**MONTANA ALBERTA TIE LTD. (MATL)
CERTIFICATE OF COMPLIANCE AMENDMENT
for Diamond Valley South and Bullhead Coulee
North Amendments**

**FINAL
ENVIRONMENTAL ASSESSMENT**

July 22, 2011

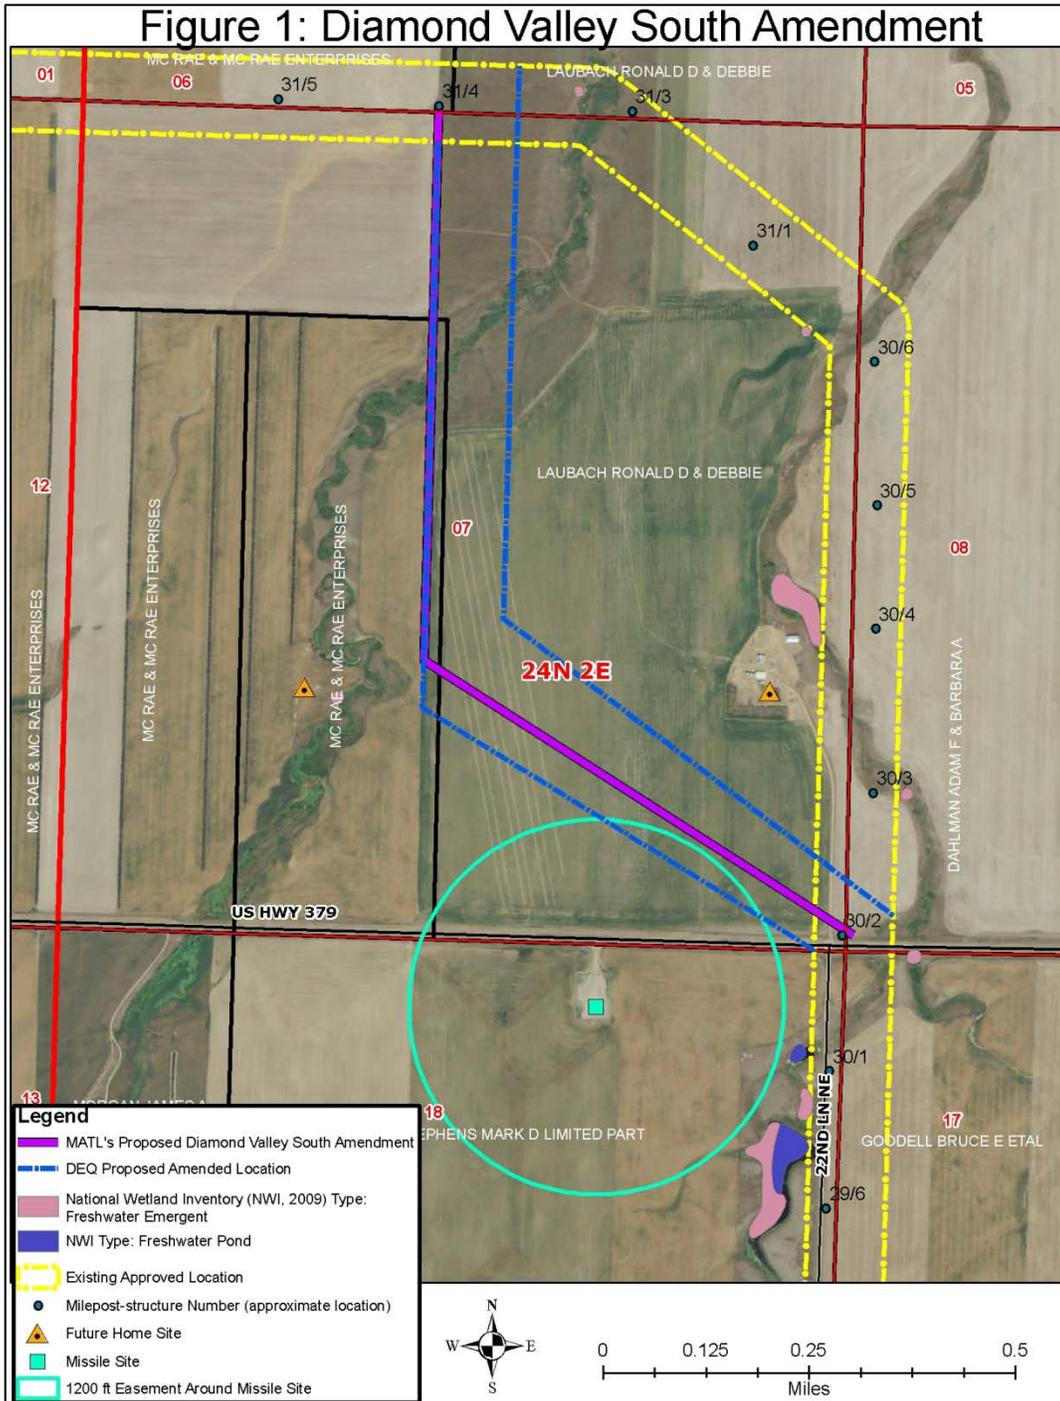
1. We find the Environmental Assessment to be inaccurate page 9, number 8 aesthetics. We disagree that the Amendment will reduce aesthetic impacts. The proposed corridor will negatively affect our recreational hunting area. It will place the line much closer to our planned house site and be much more visible from the state highway.

2. The original corridor had two guy-wired structures which should have been made into a corridor with one guy-wired structure. The new corridor has three guy-wired structures, all in cultivated land. Page 10, Number 12 going from one guy wired structure to three guy-wired structures in cultivated land would cause serious adverse impacts to agricultural activities.

As to the Diamond Valley South Amendment illustrated in EA, Figure 1, I have two concerns which should not be interpreted as opposition to the proposed change. The discussion in the EA Checklist ¶5.0 is incomplete regarding §§ 8 and 12:

Section 12. INDUSTRIAL, COMMERCIAL AND AGRICULTURAL ACTIVITIES AND PRODUCTION should include discussion regarding the effects, if any, of the proposed changes on contiguous landowners. Linear facilities cannot be properly analyzed based simply on what happens to one landowner. Any location change affects adjacent property owners, especially when the line turns at new 90° angle. The EA is silent on this matter which does not seem appropriate.

Comment 16 While potential visual impacts on the Laubach and Dahlman properties may be reduced on the proposed Diamond Valley South amendment, visual impacts may increase on the McRae property to the west of the amended location. The amended location would be close to but not overlap with the hunting area and planned home site on Mr. McRae's property. DEQ completed a site visit on July 13, 2011 to confirm location of the recreational hunting area and planned house site on the McRae property. During the meeting with Mr. McRae, DEQ requested to be taken to the home site and Mr. McRae indicated there was no current access and the entire area including the house site was planted in wheat. The landowner did not identify a driveway during that meeting. Mr. McRae located the planned house site on a map as depicted on revised Figure 1.

The landowner identified general area used for hunting. It included the area along the coulee and shelterbelts north and west of the planned house site. The amended location would be east of this area and more visible to Mr. McRae than the current location. However, the amended location would be located further from Mr. Laubach's hunting area.

Comment 26 Information has been added to Section 5.0 item 8 in the EA describing the effect of the new angle structure next to State Highway 379.

Comment 27 Please see the revised Section 3.1. Based on comments the Diamond Valley South amendment's northern and western segments would be located on Ronald and Debbie Laubach's property in Section 6 and 7 in T24N R2E, including the new 90° angle structure in Section 6 T24N R2E.

Figure 2: Bullhead Coulee North Amendment

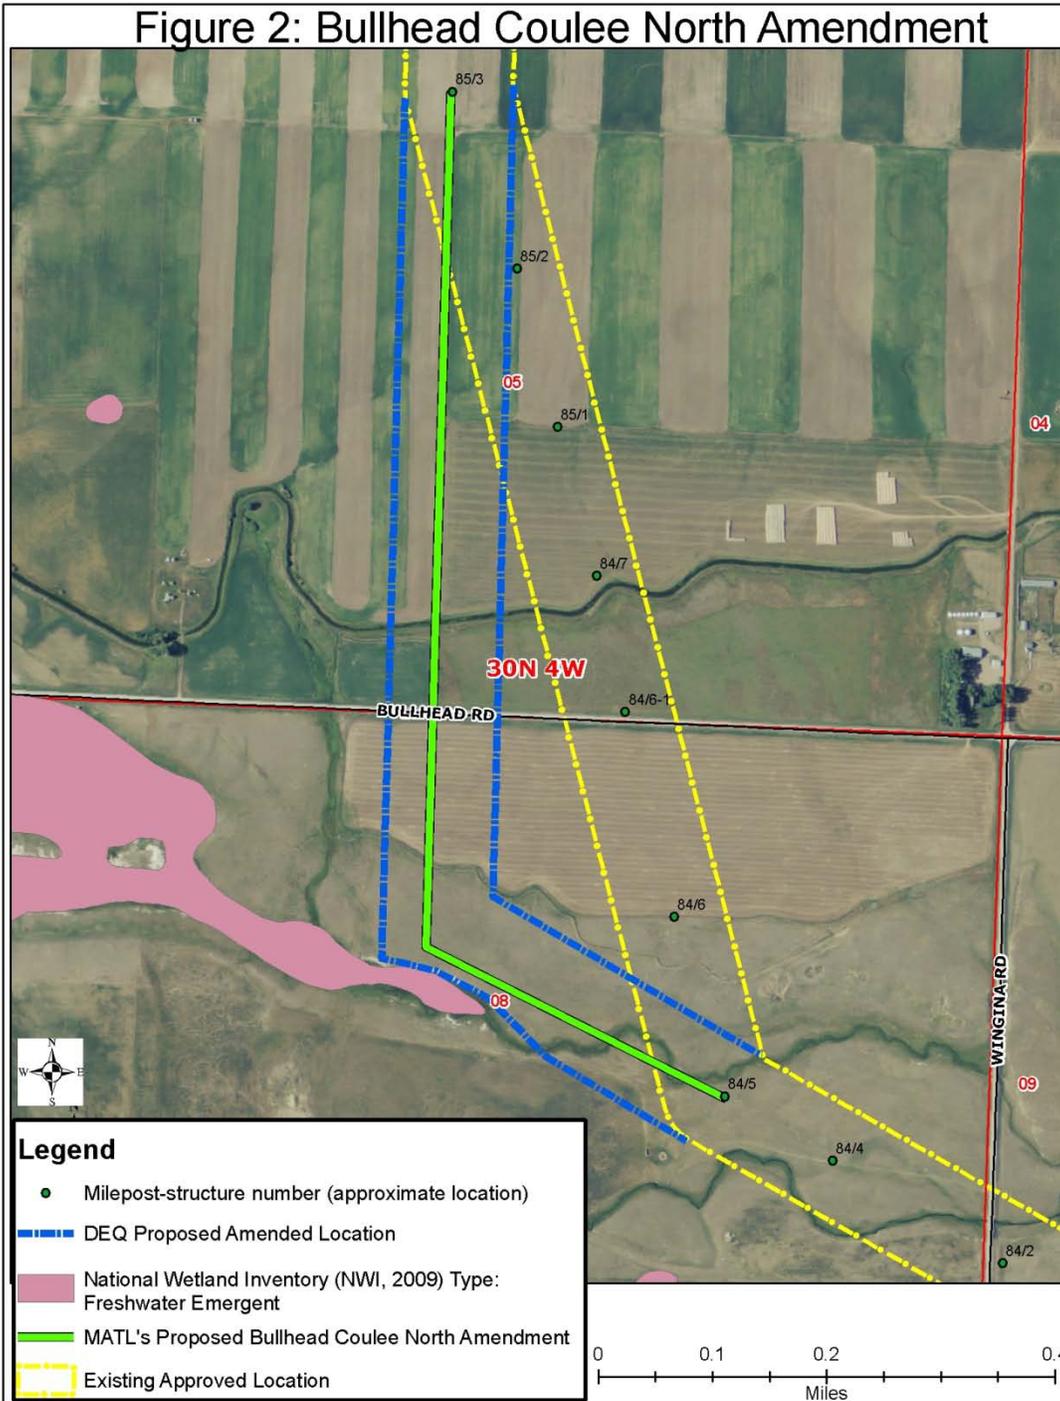
On the Bullhead Coulee North section of the relocation, the EA indicates that there would be more impacts to wetlands, riparian areas, and rangeland than in the 'no action' alternative. Specifically, two additional stream crossings would be added, and this amendment "would likely cross more riparian and potential wetland vegetation." Additionally, "slightly more rangeland and riparian habitat would be crossed." Although the fact that the permit will not allow towers and guy wires to be placed directly into a stream or wetland is helpful, the bigger impact stems from habitat fragmentation. For example, for birds, a riparian corridor is considered a body of habitat. The more times that corridor is crossed by transmission lines, the more fragmented that habitat becomes. Additionally, Montana holds the most extensive and most significant grasslands (i.e., rangeland) in the Northern Great Plains. Grassland birds show the most declines of any group of birds monitored by Breeding Bird Surveys; fewer than 30 % of the species show increasing populations. Montana is blessed with relatively healthy numbers of these species, and preserving our prairie grasslands will help to ensure that these species do not become endangered throughout their range. Fragmentation of grasslands by construction of things like transmission lines is a factor responsible for bird population declines. This occurs because many grassland birds do not tolerate towers, which fragment the habitat into smaller and less valuable patches. Towers are avoided by some species; they also introduce edge effects through fragmenting connectivity and by introducing perches for avian predators (raptors and members of the crow family (especially magpies, crows and ravens)). Additionally, fragmentation is caused by road construction associated with construction and maintenance activities.

Comment 12 For the Bullhead Coulee North area, the revised location could span two meanders of Bullhead Coulee that would result in as many as three spans of the creek by the amended location centerline submitted to DEQ by MATL. However, a close examination of Figure 2 shows that DEQ's proposed corridor is wide enough to allow an alignment that could span the coulee and associated riparian area only once. In addition, a bridge on Wingina Road may provide an opportunity to move construction equipment over the creek and associated narrow riparian area with few impacts to the creek and associated riparian vegetation. During the required field inspection, the advantages of avoiding disturbance to the riparian area would be weighed against the potential increased impacts to rangeland and cost of construction due to the additional length of off-ROW access across rangeland as opposed to keeping access closer to the centerline. Access from Bullhead Road is another possibility to reduce impacts to the riparian area.

In the Bullhead Coulee North area, rangeland has been fragmented by farming, irrigation canals, county roads, distribution lines, fences, and farm buildings. The remaining 1.6-mile long by less than 0.3-mile wide patch of rangeland between roads would be affected by either alternative. The proposed amendment would cross approximately 0.33-mile of rangeland while the currently approved location crosses 0.16-mile of rangeland. It is important to note that the owner of the rangeland in question recognizes the need for the proposed amendment and had voiced his acceptance of the change.
